**Landmarks & Urban
Conservation Commission**

Agenda Number: 4
Case No.: 17-LUCC- 50001
Project # 1011116
February 8, 2017

Staff Report

Re: Request to Build Additions - 1013 8th Street NW

ATTACHMENT A-1

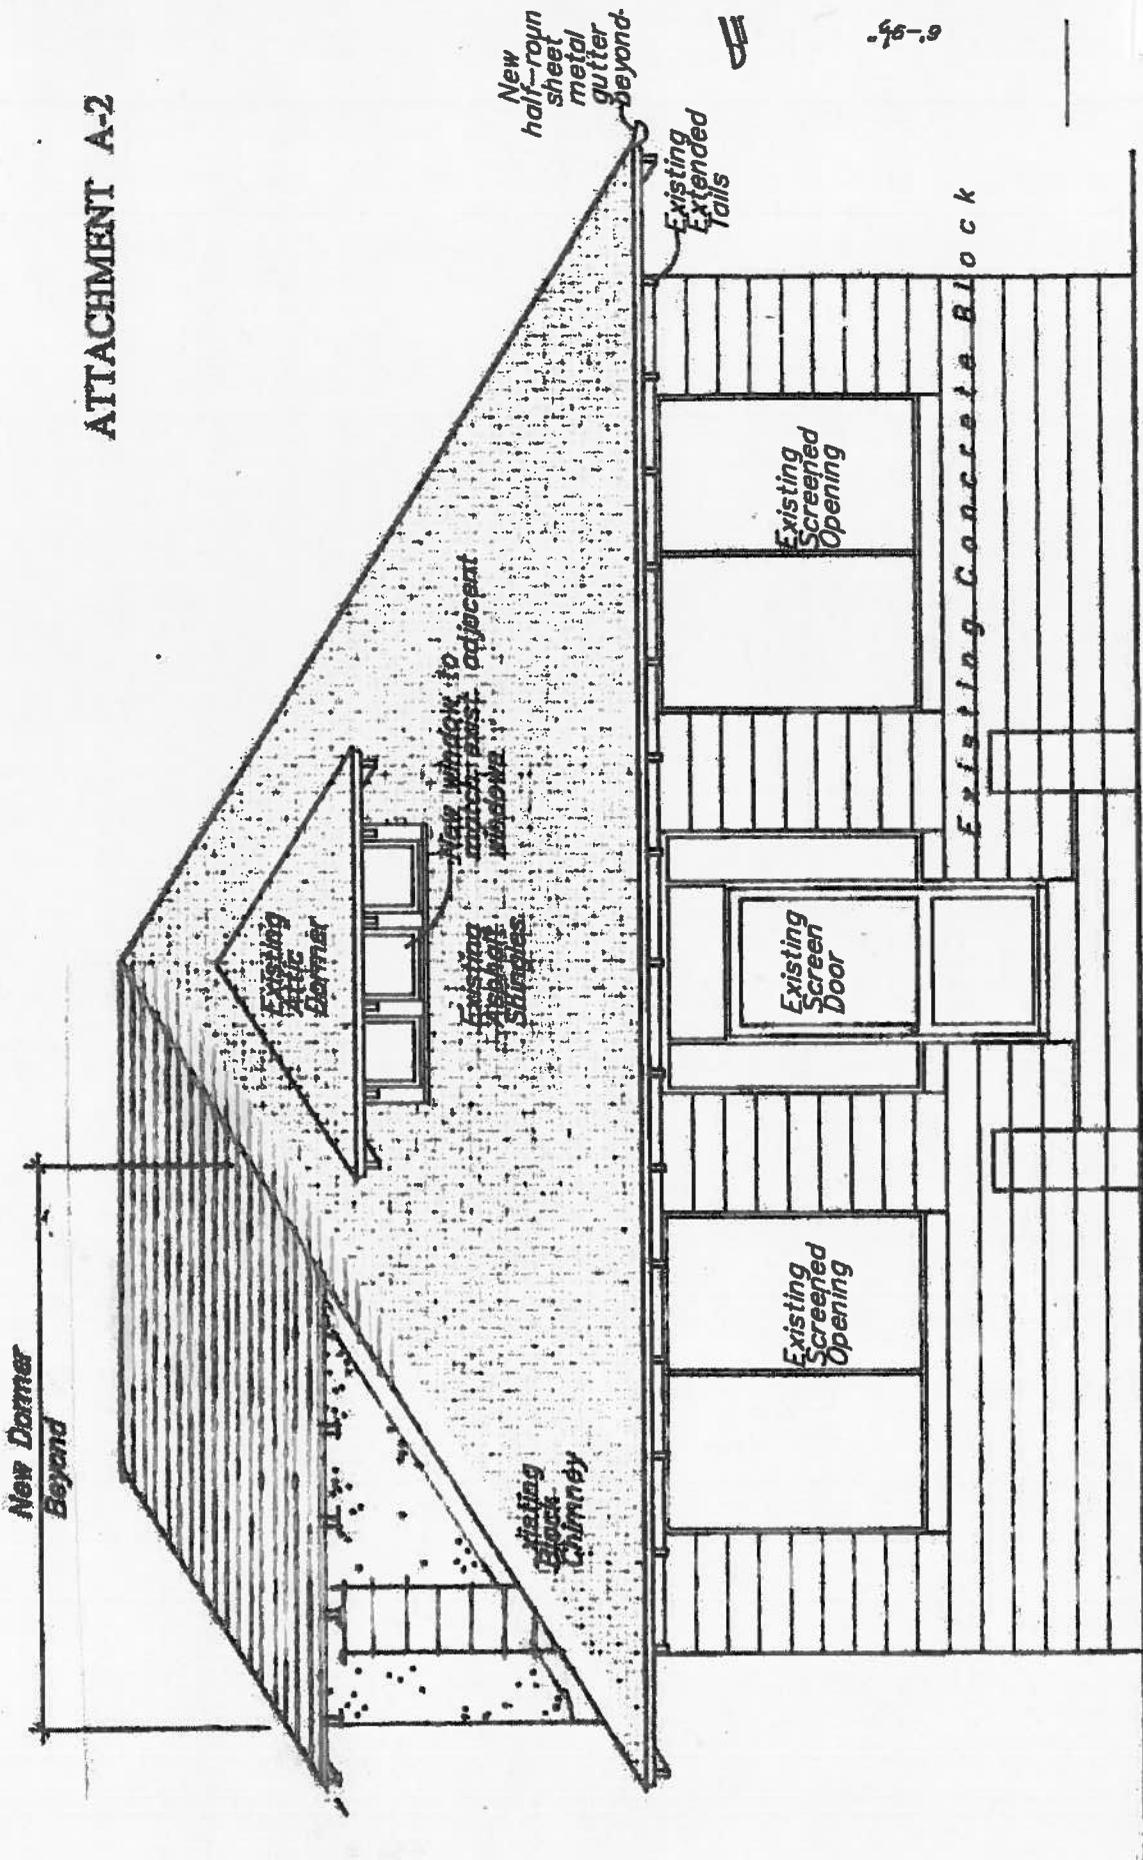
The proposal calls for the reuse of the kitchen window which is to be removed for a new outside door. While this has merits, it would require that the roof end be a gable to attain clear height. Should the design be changed to incorporate a hipped roof in keeping with the existing roof, then the opportunity arises to utilize a smaller window in a three window pattern similar to the existing front dormer. (See Attachment 1)

ATTACHMENT A-2

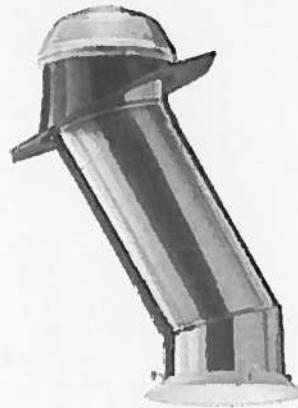
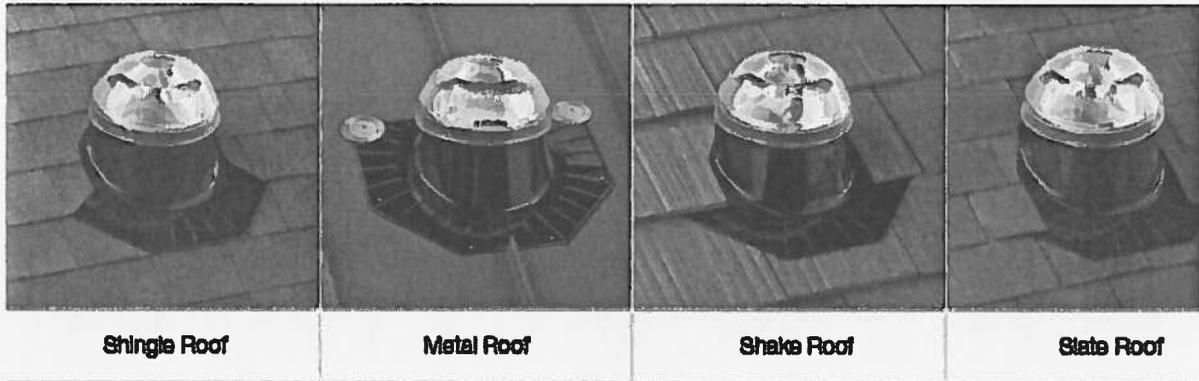
Of the two dormers, the rear dormer with the gabled end does not affect the street facing elevation. The design also requires the full height for the placement of a central door opening on to a small balcony. The side gabled roof; however, does not best serve the front elevation. Staff proposes a reduction to the overhang to be in keeping with the existing front dormer and the incorporation of a hipped roof instead of the gable end. The hipped roof would result in lessening of the head clearance at the end of the room but it would still provide the code minimum of 5'-0". (See Attachment 2)

Staff recommends against the incorporation of the gabled roof for the new side dormer as it is not consistent with the existing roof and would better suit the existing house if it were a hipped roof. The gabled roof end on the rear dormer is reasonably compliant as far as materials and necessary for proper functioning of the room.
